# INVITATION TO TENDER "ITT" NO. PS20170908
## CONSTRUCTION SERVICES FOR INTERIOR OFFICE RENOVATIONS AT 236 E CORDOVA STREET

## QUESTIONS AND ANSWERS NO. 2

**ISSUED ON 2017-10-05**

**SK - 1**

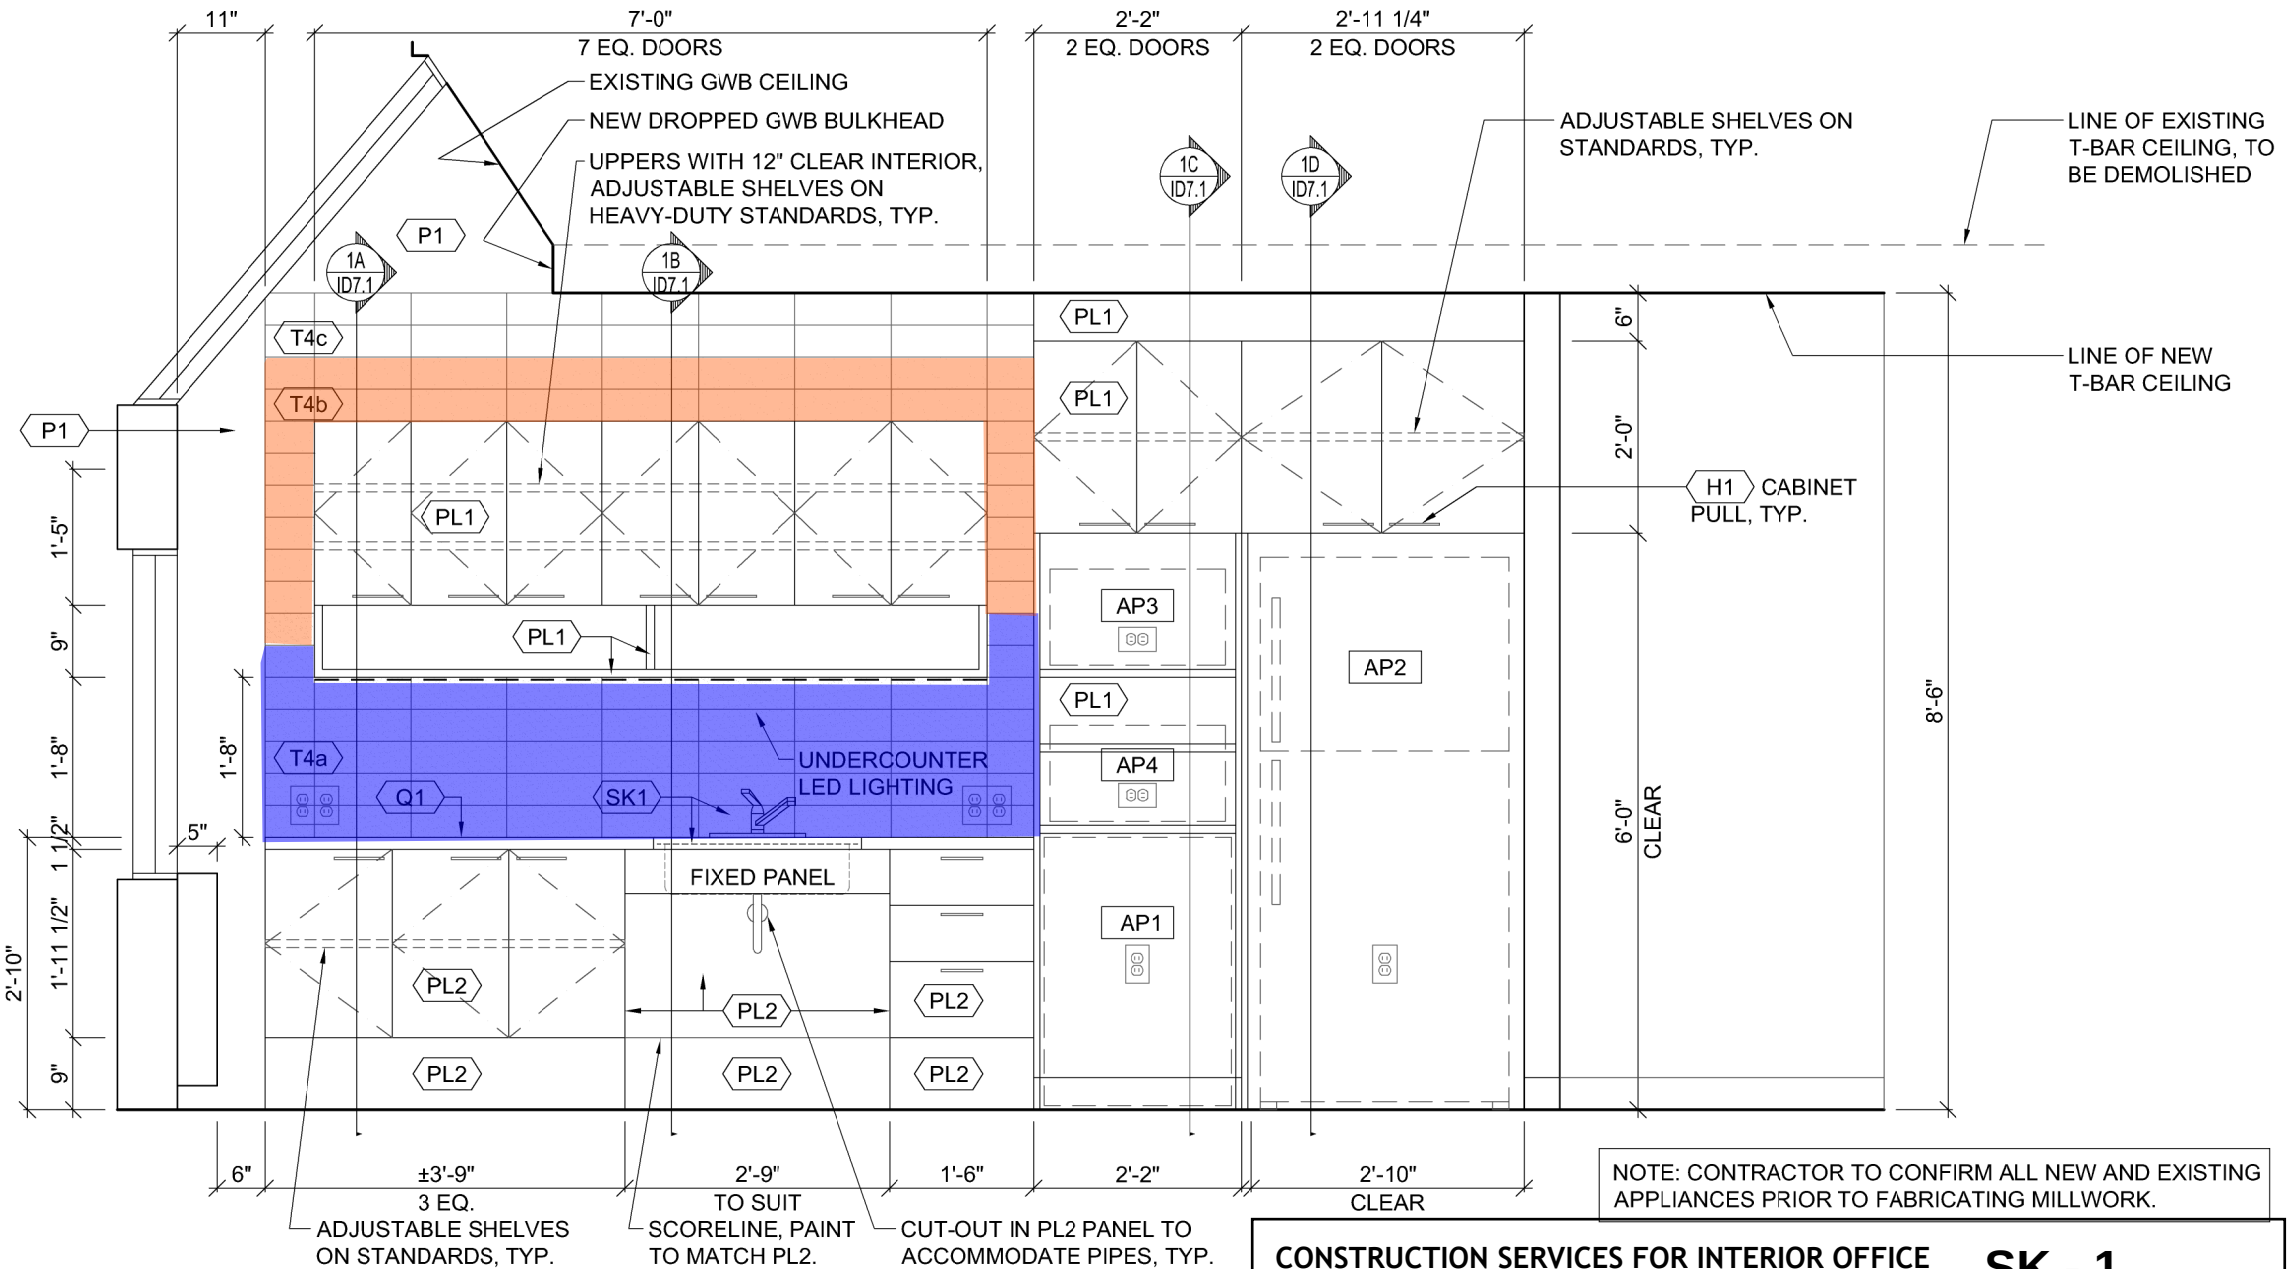
| **Q14** | Elevation 2 on drawing ID6.1 (2/ID2.1) needs clarification as to the layout of T4a / T4b & T4c at the backsplash. |

| **A14** | **Refer to sketch SK-1 attached** |

**SK - 2**
**OCT 3, 2017**

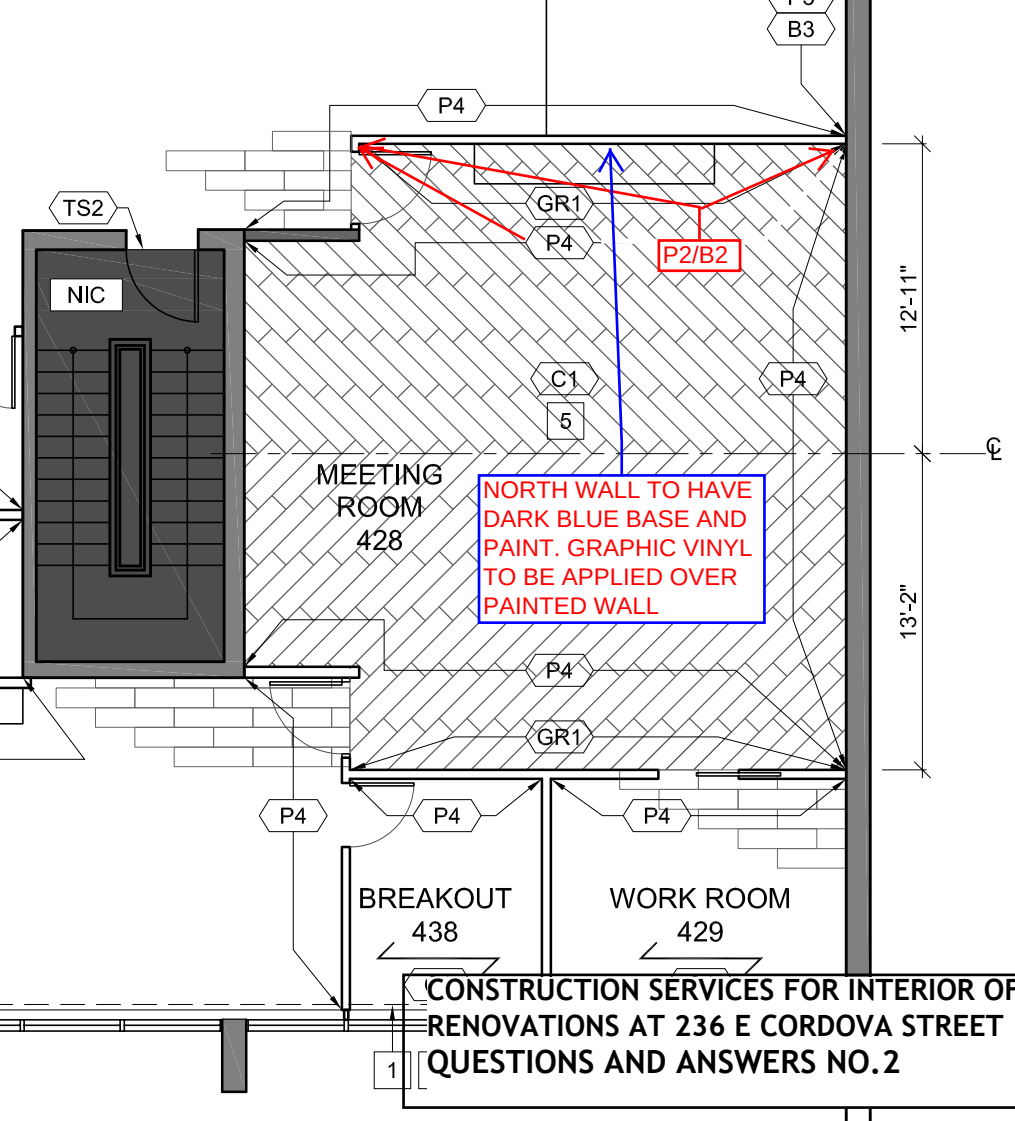
| **Q12** | B2 is called for at P2 wall locations however, on drawing ID3.1 neither B2 nor P2 are shown? Are they required anywhere? |

| **A12** | **B2 and P2 are on North wall of Meeting room 428. See SK-2 attached.** |

| CONSTRUCTION SERVICES FOR INTERIOR OFFICE RENOVATIONS AT 236 E CORDOVA STREET<br>QUESTIONS AND ANSWERS NO.2 | **SK - 3**<br>**OCT 3, 2017** |

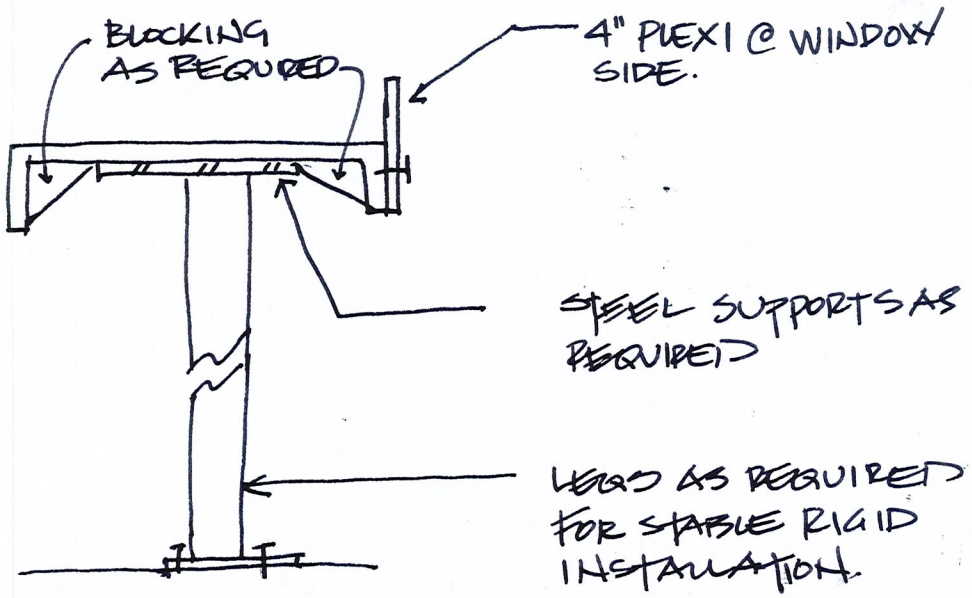
| **Q7** | Please provide section detail of the Lunch Room Eating Bar. According to 3/ID6.1 there is supposed to be SEC detail 1D/ID7.1, however this detail is mislabeled and not actually on the drawings. Also, is there a specification for the metal leg for this eating bar? |

| **A7** | **Refer to SK-3 Attached.** |
